Re: Docket No. 40-8903
License No. SUA-1471
Up-date of Table 2 – Groundwater Monitoring Program (8-97)

TABLE 2 – Groundwater Monitoring Program (8-99)

**TREND ANALYSIS FIGURES
FOR
TABLE 2 MONITORING WELLS

Figure 1 #1 Deepwell

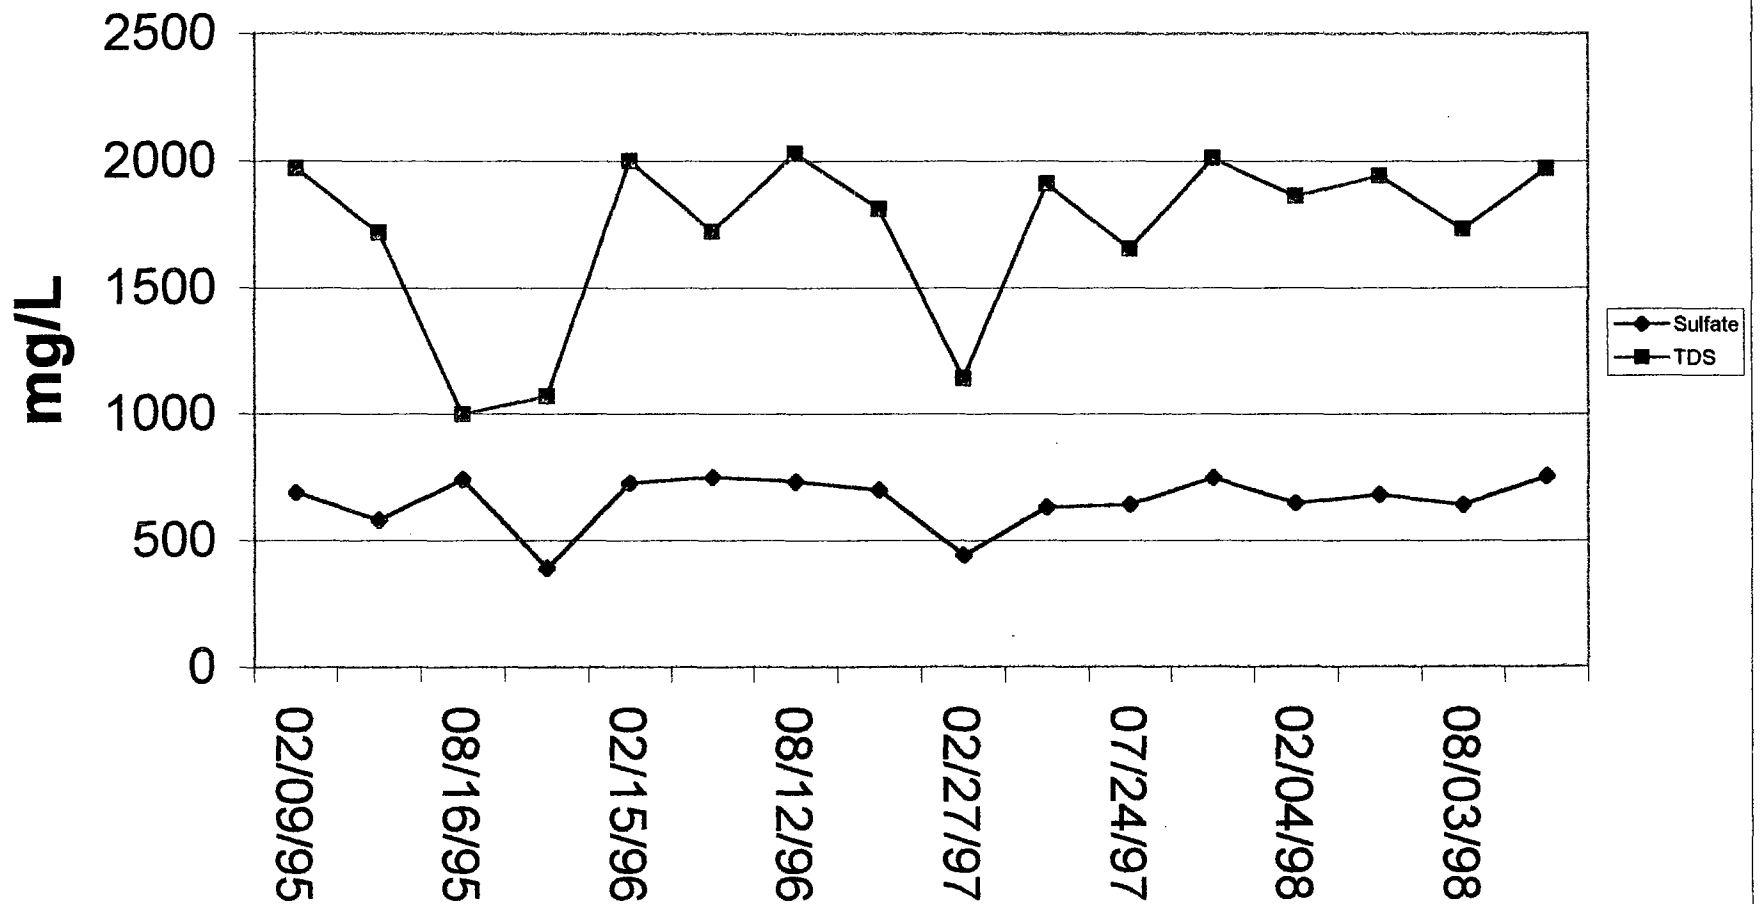
- **#1 & #2 Deep wells** – We will eliminate the quarterly sampling for sulfate and total dissolved solids. Trend analysis has shown that though these parameters fluctuate, there is no upward or downward trend over time (refer to Figures 1, and 2). These wells presently supply water to our injection system and will continue to supply water to portions of our injection system when the R.O. facility comes on-line. Therefore, we will continue to monitor these wells annually for the D list of parameters.

Figure 3
Well 0446

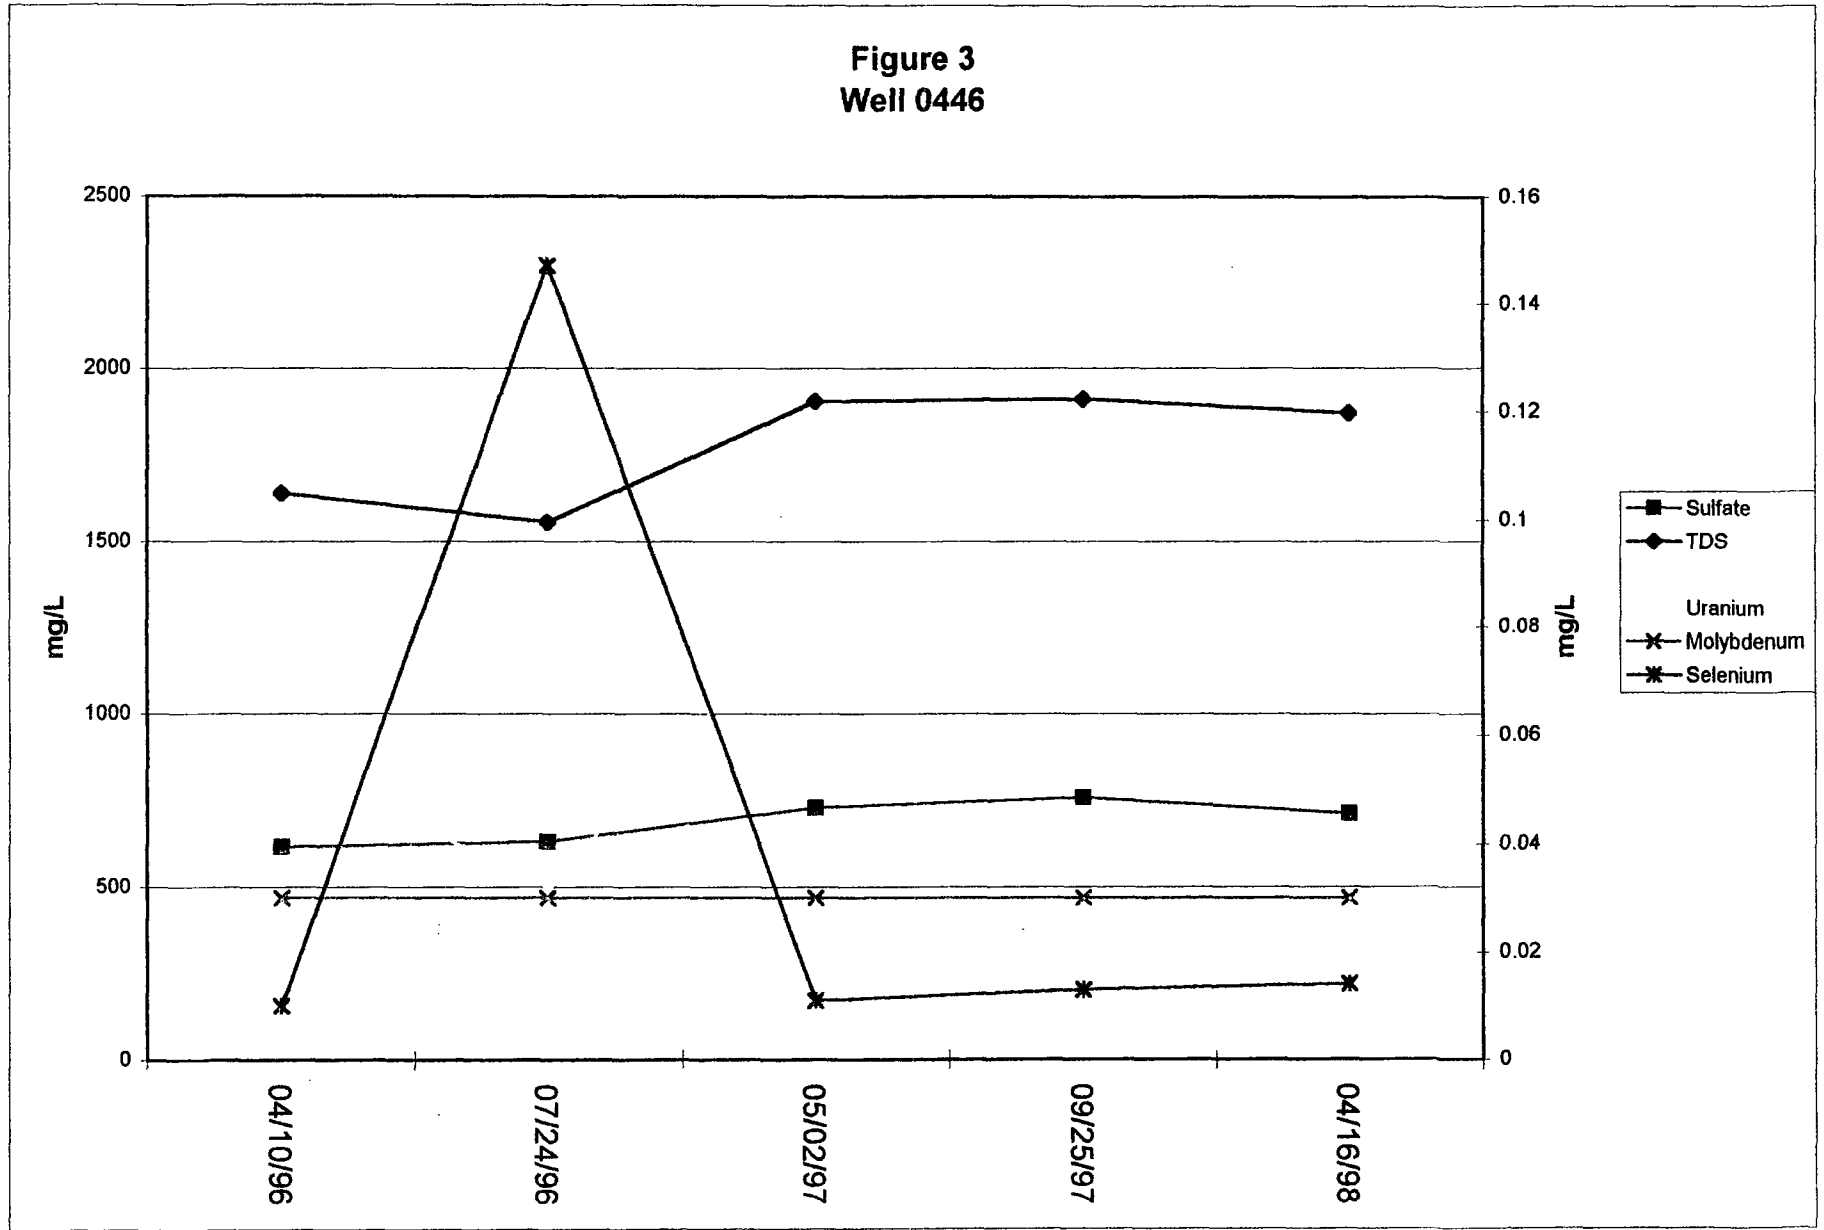
- **Broadview Acres** – We will continue monitoring wells 446, SUB1, SUB2, and SUB3 for the G list of parameters, though only on an annual basis. The trend analysis for these wells has shown that changes in concentrations are not seasonal and annual monitoring should be adequate (refer to Figures 3, 4, 5 and 6). Wells 434 and 453 will be eliminated from the monitoring program. The trend analysis for these wells has shown that the concentration of contaminants has been reduced to below site standards (refer to Figures 7 and 8).

Figure 9
Well 0490

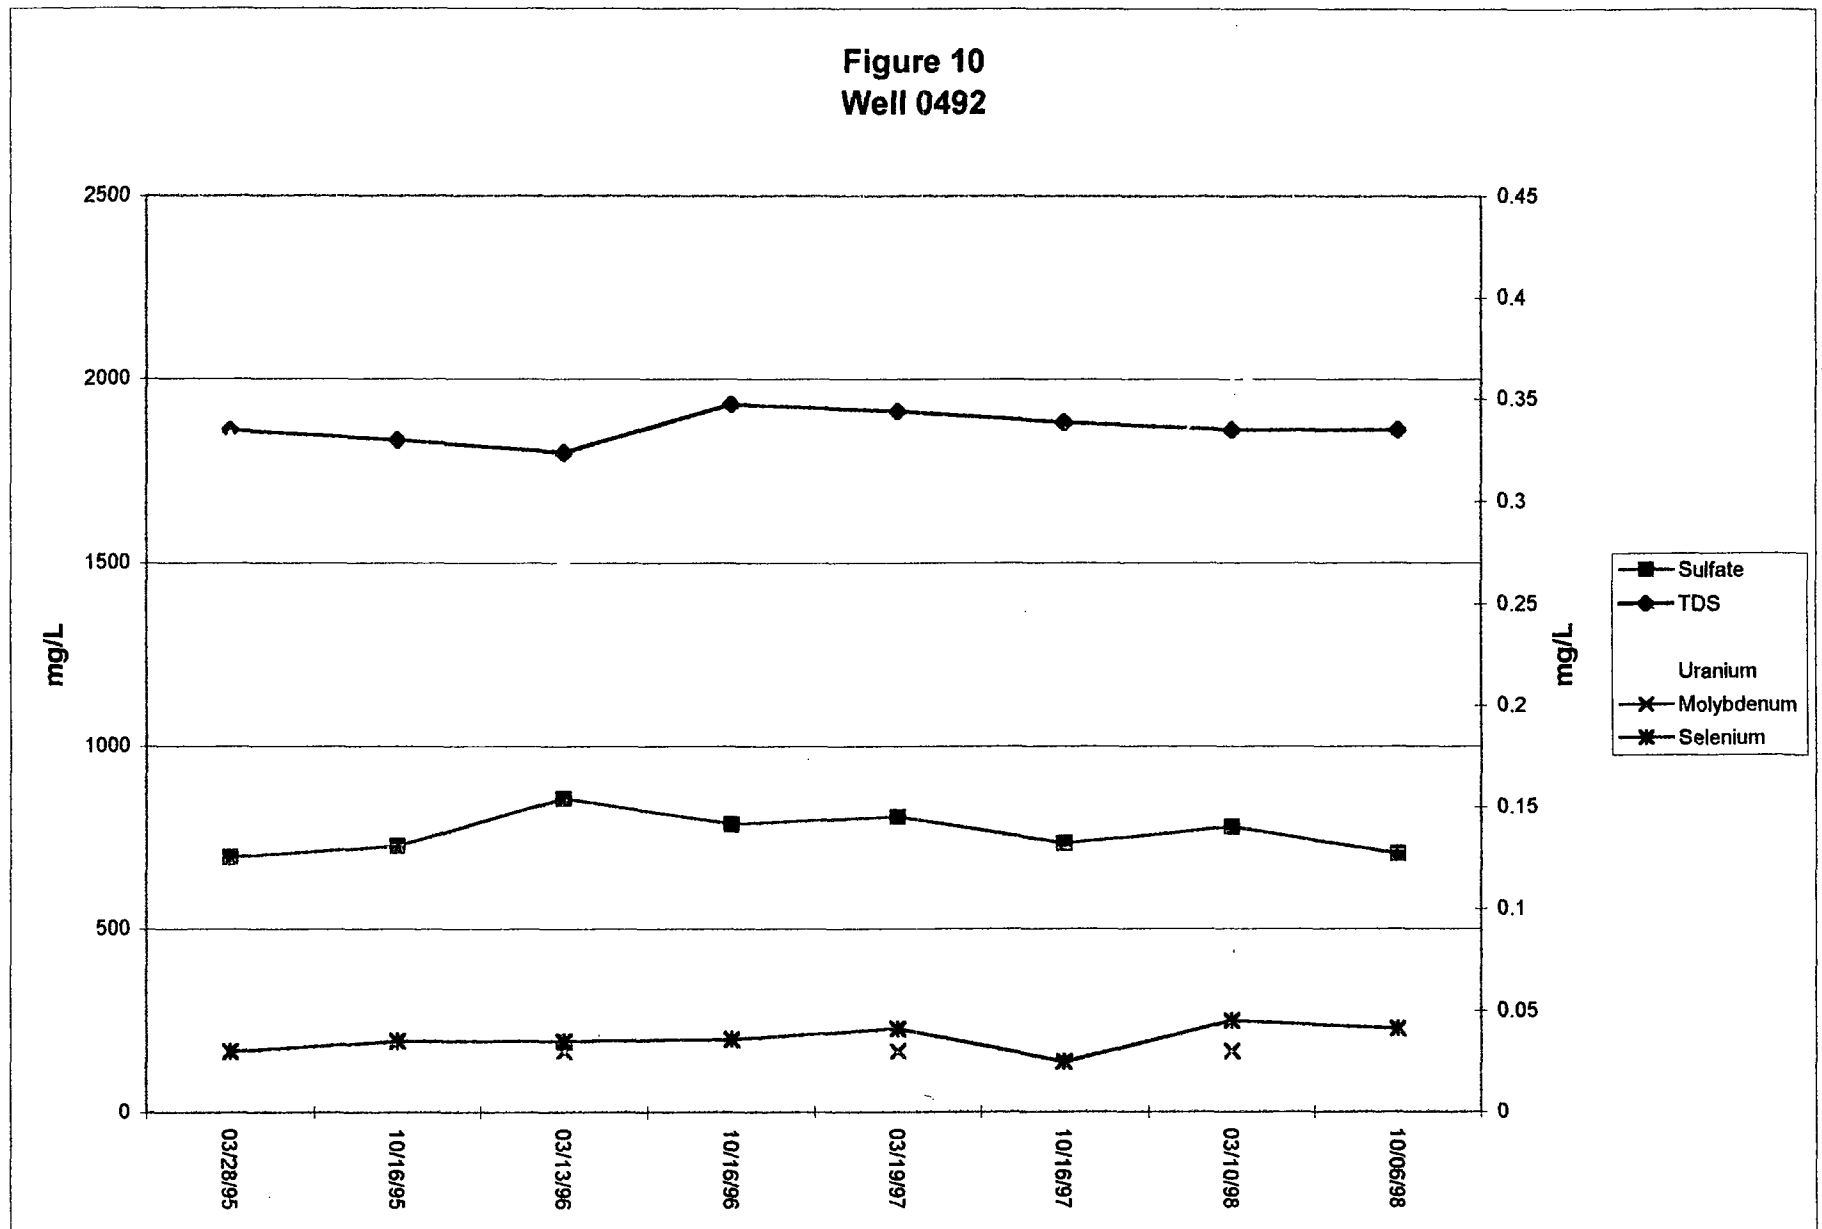
- **Felice Acres** – We will continue to monitor wells 490, 492, 493 and 494 for the G list of parameters, though only on an annual basis. The trend analysis for these wells has shown that changes in concentrations are not seasonal and annual monitoring should be adequate (refer to Figures 9, 10, 11 and 12).

Figure 13
Well 0802

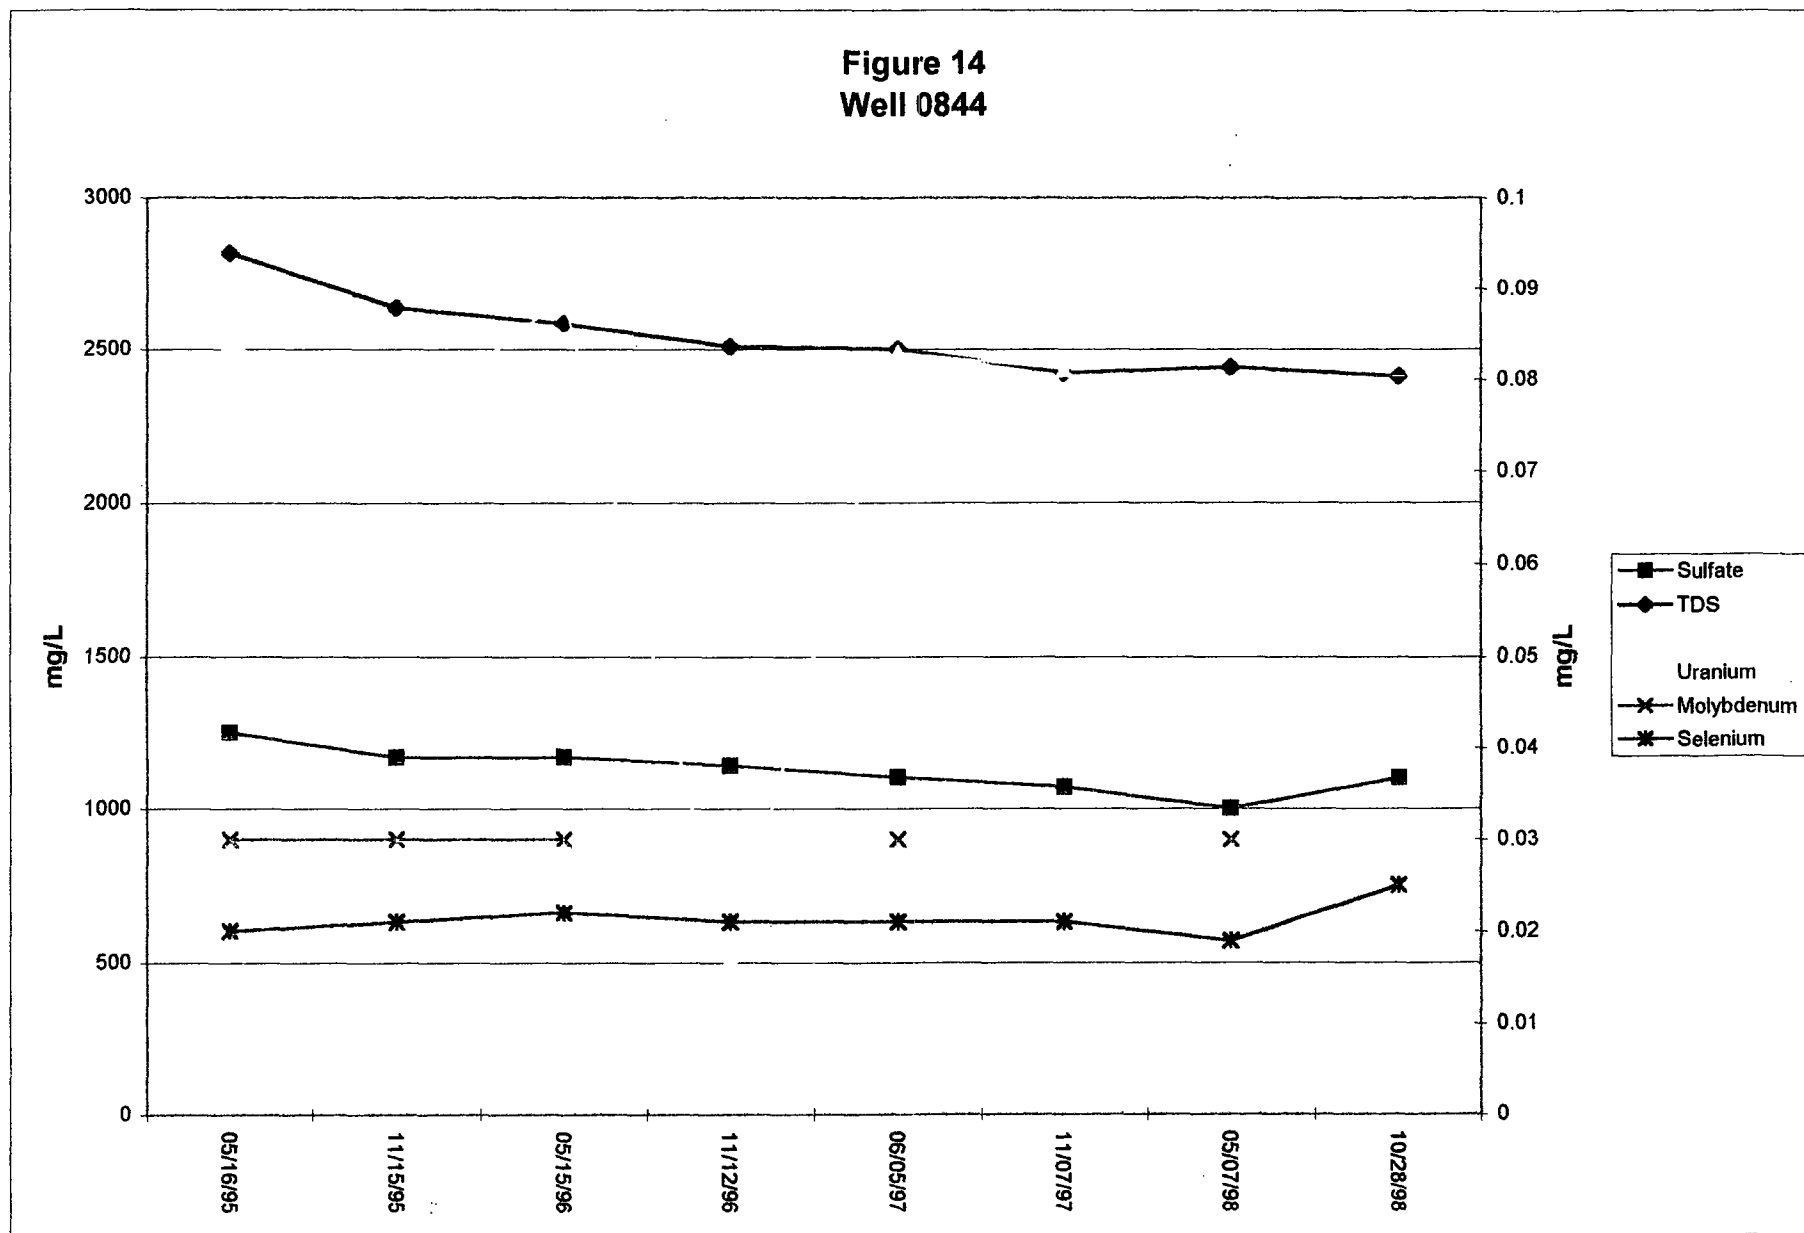
- **Murray Acres** – We will monitor, on an annual basis, wells 802, and 844 for the G list of parameters. The trend analysis for these wells has shown that changes in concentrations are not seasonal and annual monitoring should be adequate (refer to Figures 13 and 14). We will eliminate wells 804, 820 and WCW from the monitoring program. The trend analysis for these wells has shown that the concentration of contaminants remain below site standards (refer to Figures 15, 16, and 17).

Figure 18
Well 0688

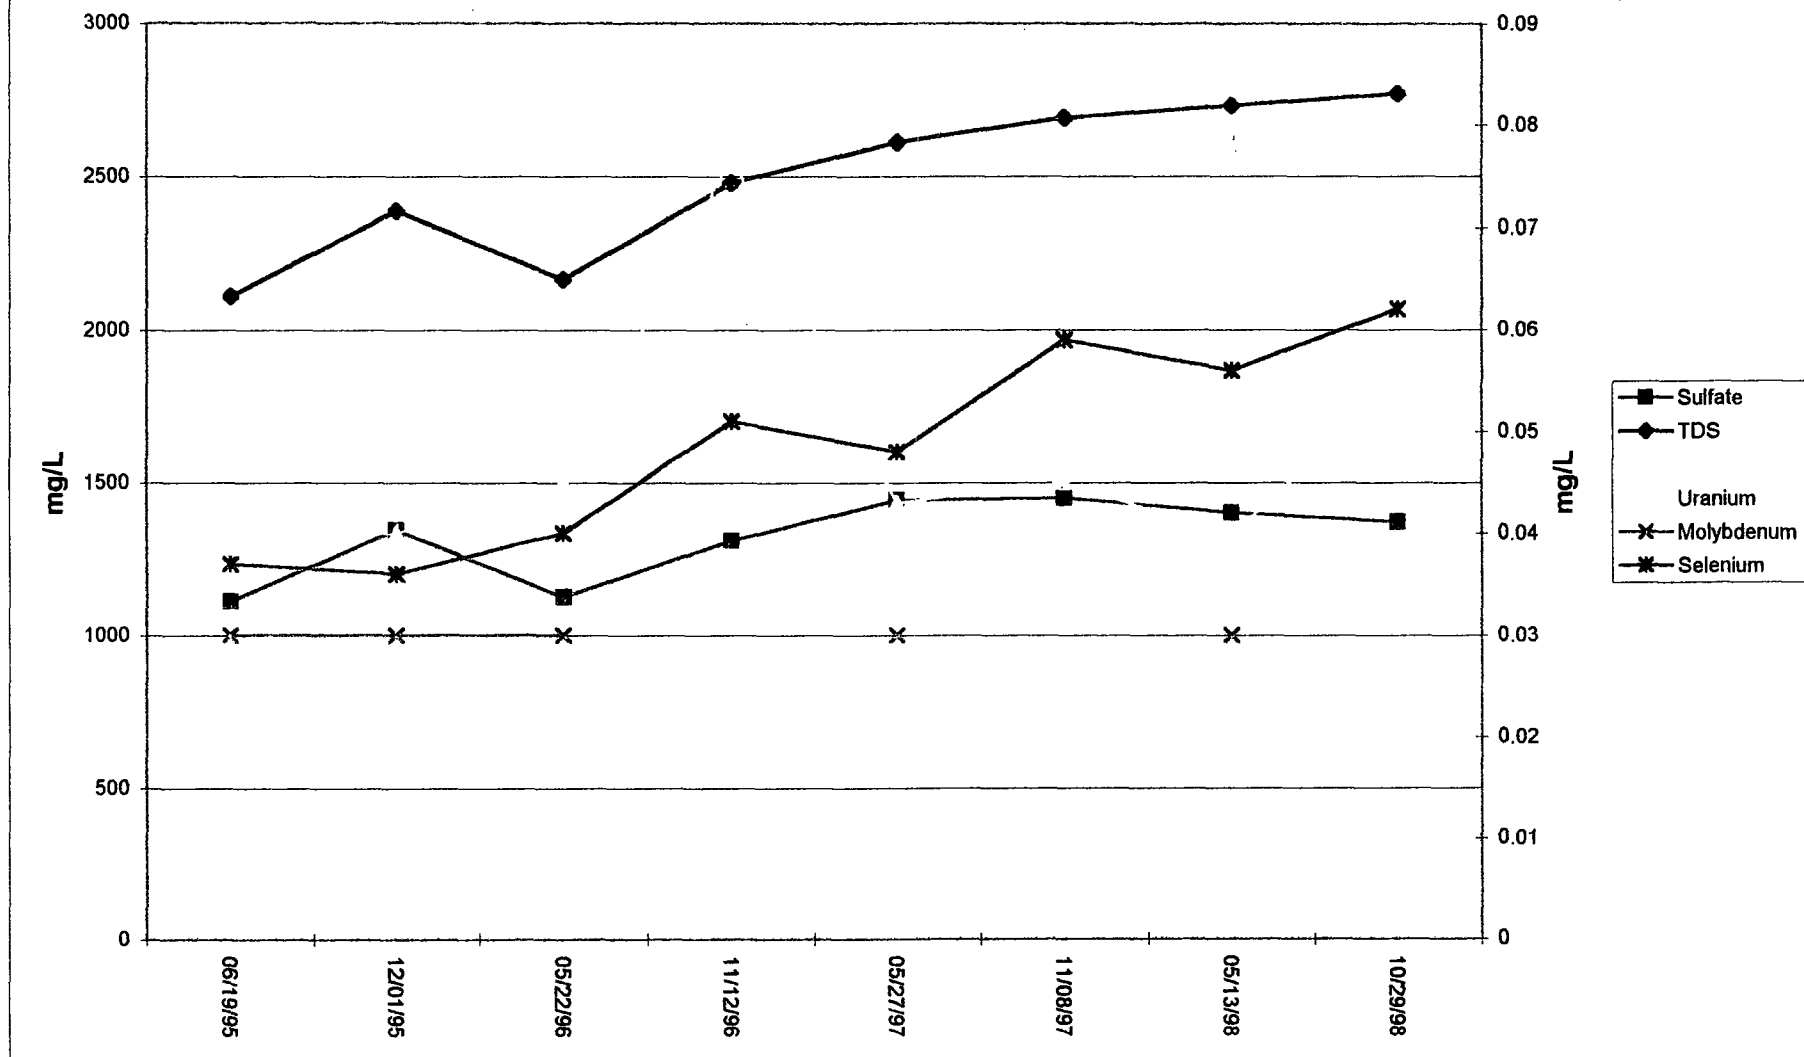
- Pleasant Valley –Well 688 and 846 will be monitored annually for the G list of parameters. The trend analysis for this well has shown that changes in concentrations are not seasonal and annual monitoring should be adequate (refer to Figure 18 and 19). Well 835 will be eliminated as a monitoring well. It is an old well on private property. The pump no longer works and we were not able to collect a sample in 1998. We feel that wells 688 and 846 will adequately monitor the Pleasant Valley area.
